Fortune Minerals Limited NICO Cobalt-Gold-Bismuth-Copper Project

Information Request Responses

Mackenzie Valley Review Board 200 Scotia Centre PO Box 938 Yellowknife, NWT, X1A 2N7 Canada

Report Number: 09-1373-1004 **December 2011**

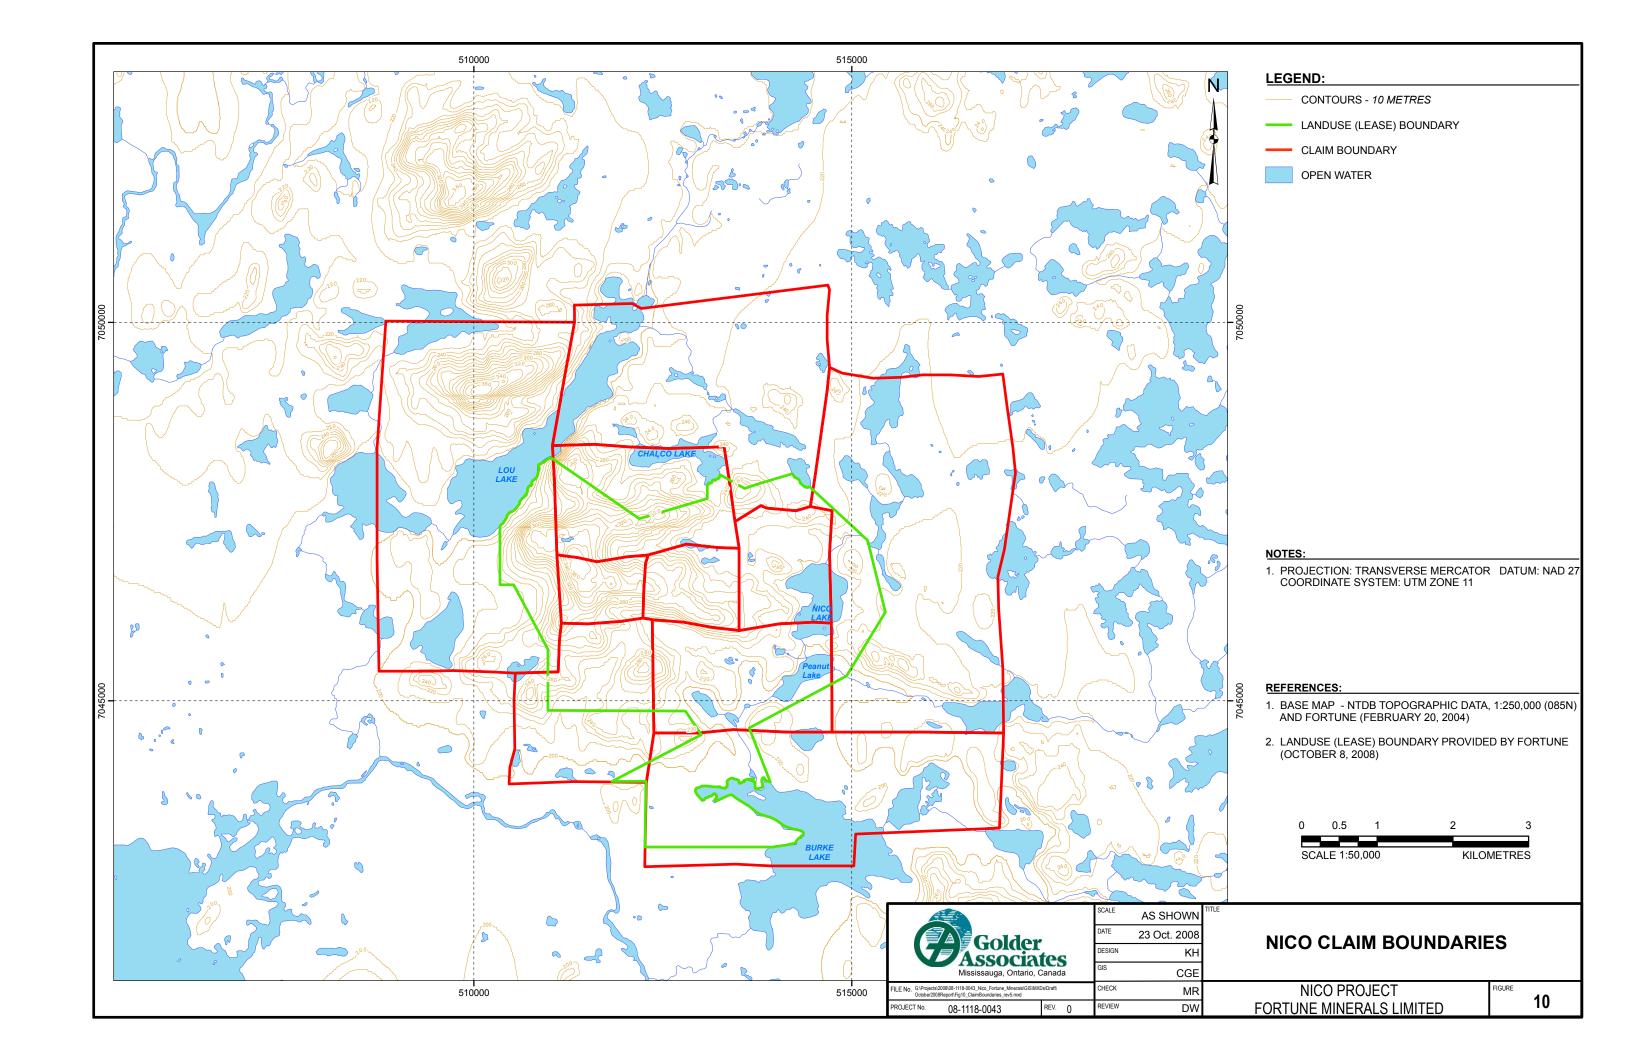
- 3.1) Given the scope of development (aka the proposed Project) defined by the Review Board includes the NPAR, and the NPAR is largely if not wholly on Tłįcho Lands, please clarify the statement from section 5.1.2.1.
- 3.2) Please provide a map indicating land ownership status for the entire area encompassed by the scope of development, with an emphasis on the NPAR and mine site areas. Currently Figures 5.1-1 and 5.1-2 do not show this in enough detail.
- 3.3) Please discuss which parties have responsibilities for managing which lands in the area potentially affected by the proposed development, with reference to the above requested map.

The precise location of the NICO claim boundaries were provided in Figure 10 of Fortune's water license application in January 2009 (see attached). The NICO mine and part of the NICO Project Access Road (NPAR) are within the boundary of the mine claims. Outside of the mine claim boundary, the NPAR is on Tłįchǫ fee simple lands.

Figure 1: Modelled Relationships Describing Parturition Rates as a Function of Body Weight, as Part of the Energetics Assessment

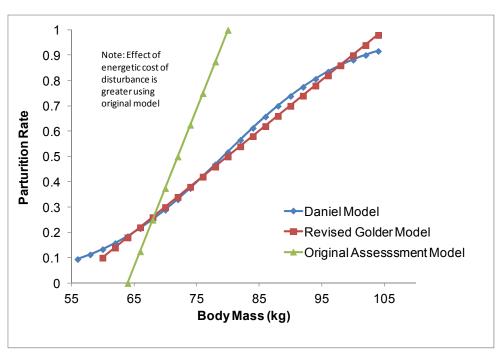
Another key assumption of the energetic model was related to the relationship described for weight loss and parturition rate (Figure 1). The Developer's Assessment Report (DAR) model assumes that parturition rate decreases by 0.0625 units per 1 kilogram (kg) loss of body weight. This assumption and model was deemed very conservative compared to a new model, the "Daniel" model, being considered by ENR (Daniel et al. 2009). The Daniel model assumes a decrease of about 0.02 units per 1 kg loss of body weight (see Figure 1 below).

If assuming that mass loss from one disturbance event is 0.0471 kg (see Section 8.5.4.2 in DAR), female caribou would be required to come into contact with almost 1000 such disturbances to reduce parturition rates from 1.0 to 0.5 (by 50%) under the Daniel relationship; whereas female caribou would have to come into contact with 340 disturbance events to result in no reproduction the following spring using the parturition rate-body mass relationship in the DAR. For a landscape in which an individual in a population encounters an average of 40 sensory disturbance events in its winter range (see Golder 2011), the Daniel model predicts that parturition rates of the female would be reduced by approximately 0.038 units (vs. 0.118 units from the DAR model). The main point is that the parturition rate-body mass formula in the DAR is more than 3-times stronger (more conservative) than that described using the Daniel model. This is another example where the DAR has clearly overestimated effects to caribou.

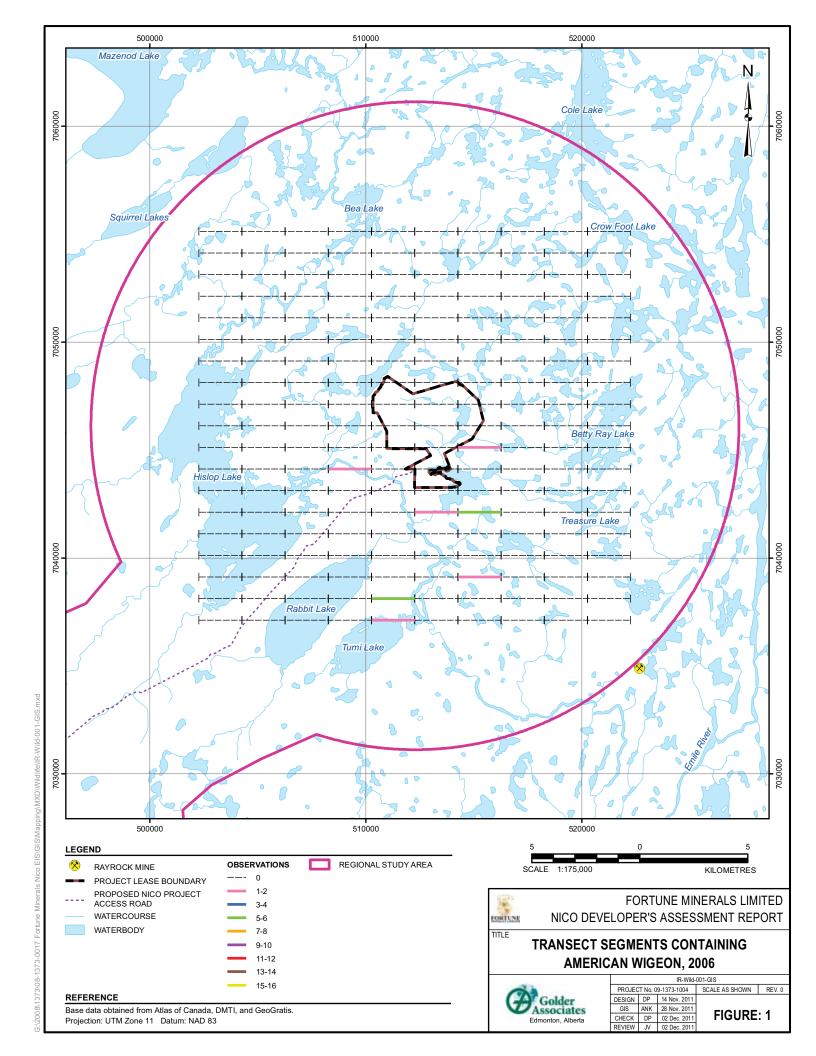
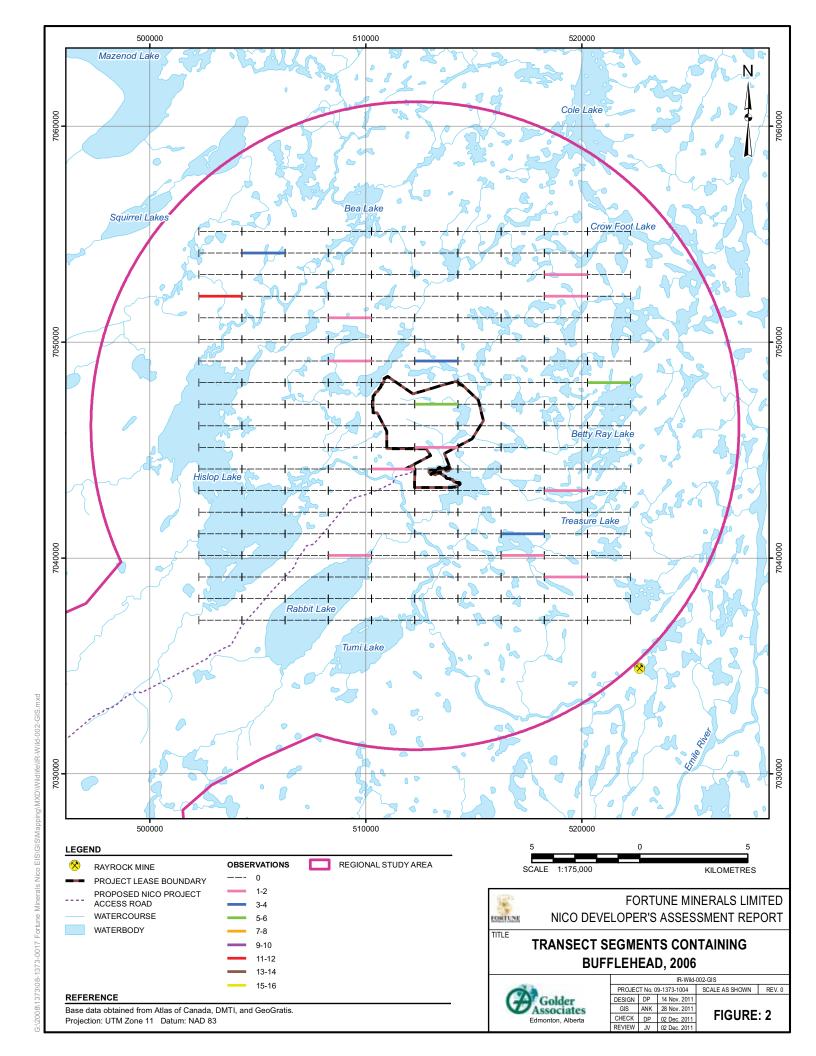
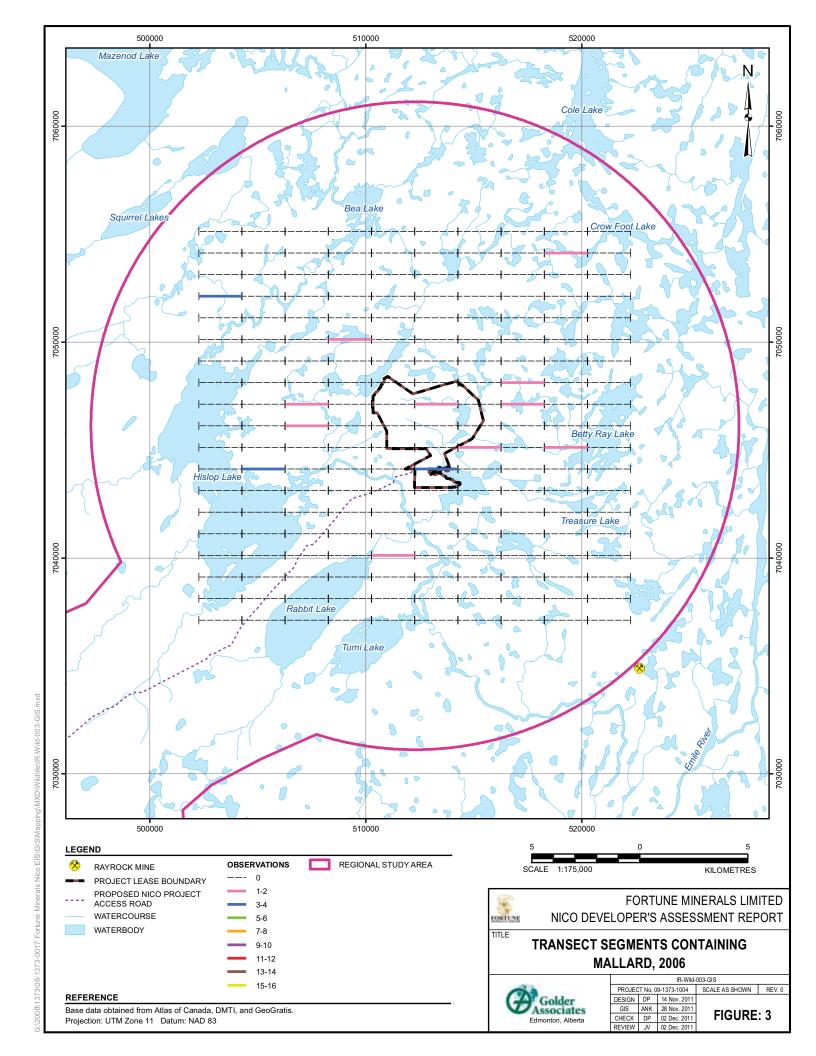
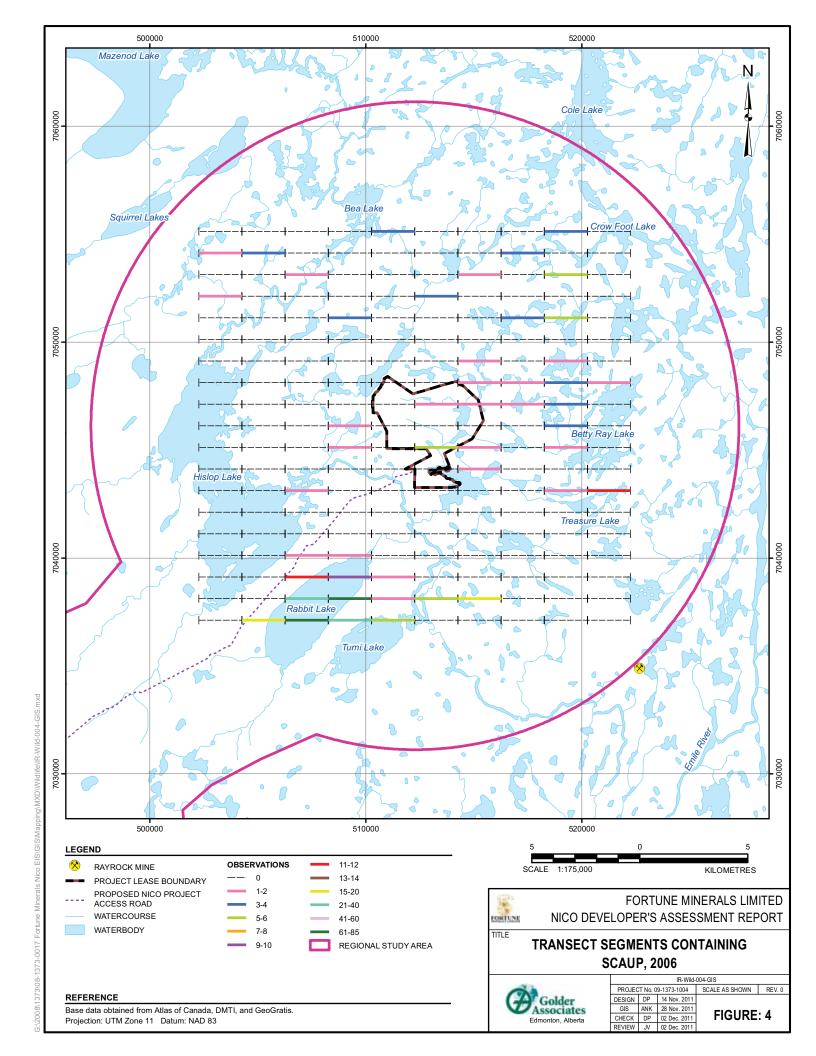
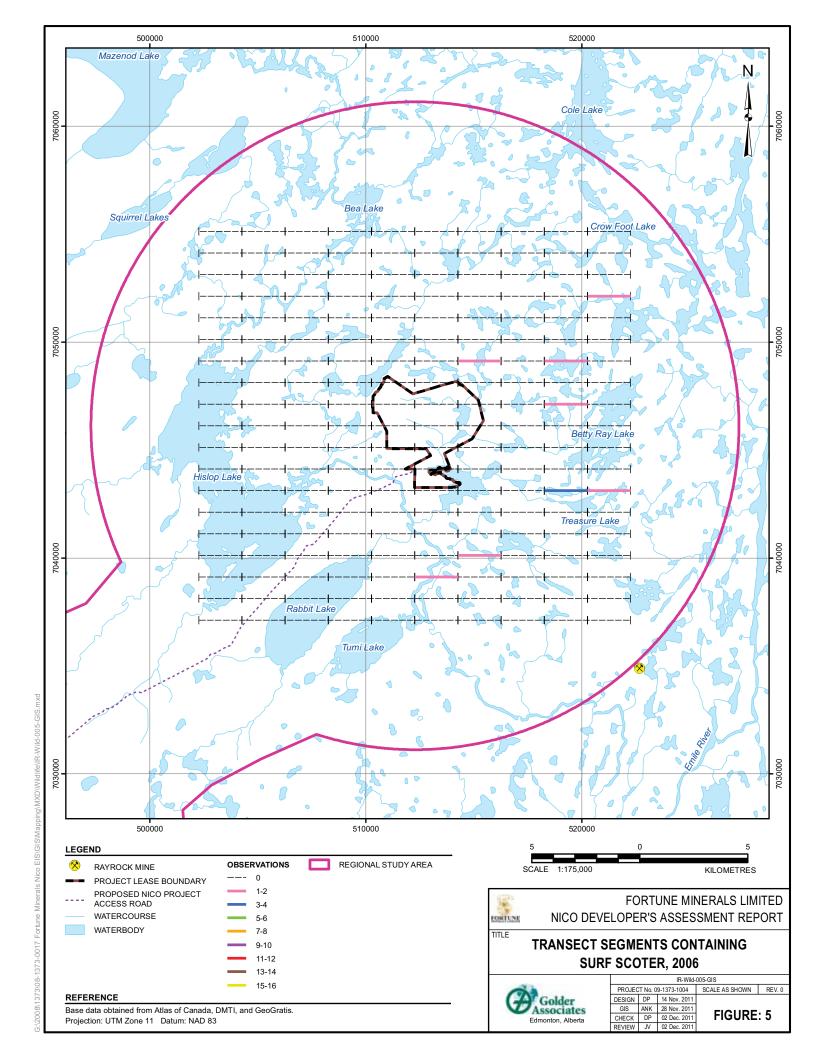
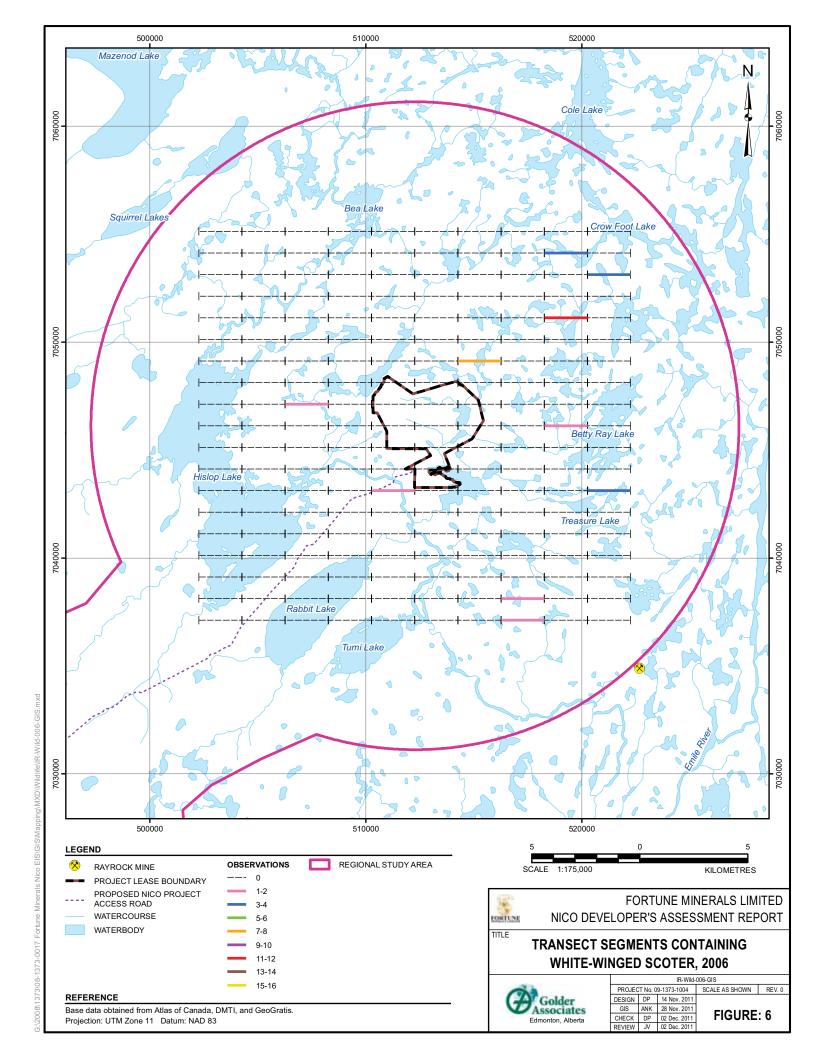
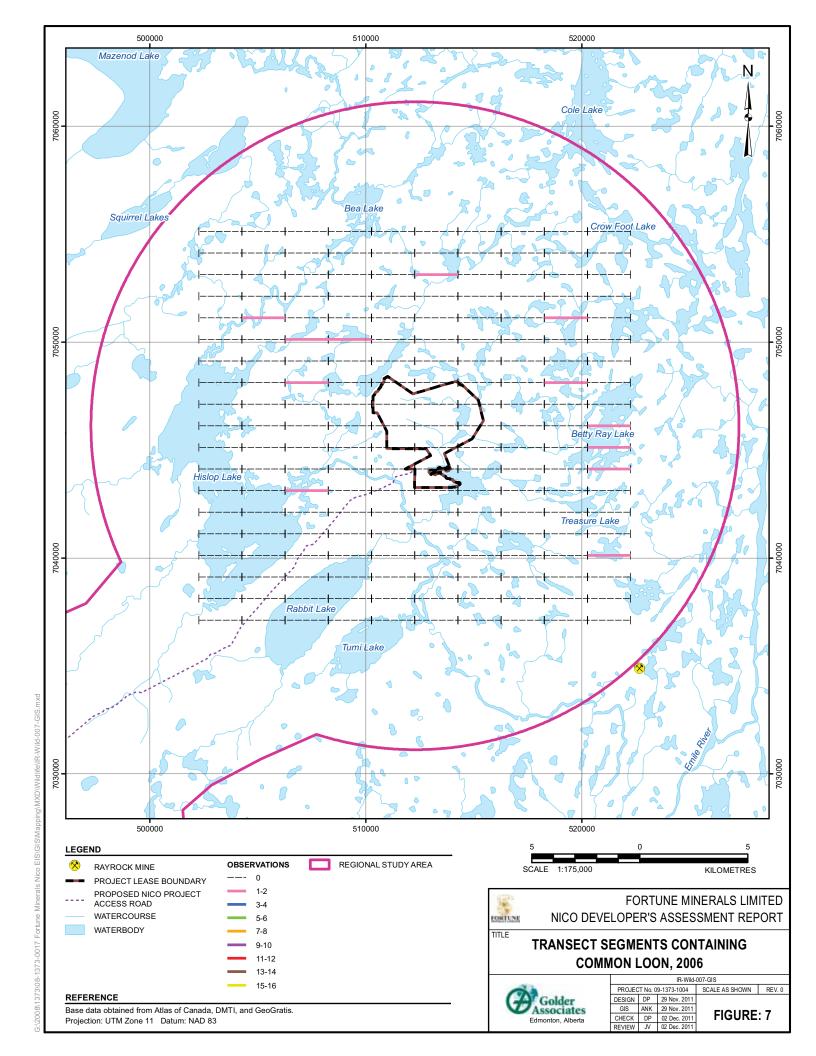
Provide revised waterbird maps that show areas of different waterbird densities by species or major bird groups (e.g., loons, grebes, ducks, geese, swans, terns) and by season using density contour maps or a similar technique.

Surveys of waterbirds completed on 4 June and 27 July 2006 followed methods similar to those outlined in Hines and Robertson (2006), in that waterbirds were counted by flying transects and recording observations made in each 2 kilometre segment of each transect. Detailed methods are provided in the Baseline Wildlife and Wildlife Habitat Report (Annex D of the Developer's Assessment Report). Detailed maps of waterbird observations from these surveys are provided here, Figures 1 to 7. Maps are presented only for species where more than 10 individual birds were observed, not including chicks. The response to Information Request EC_5 presents the number of birds observed.
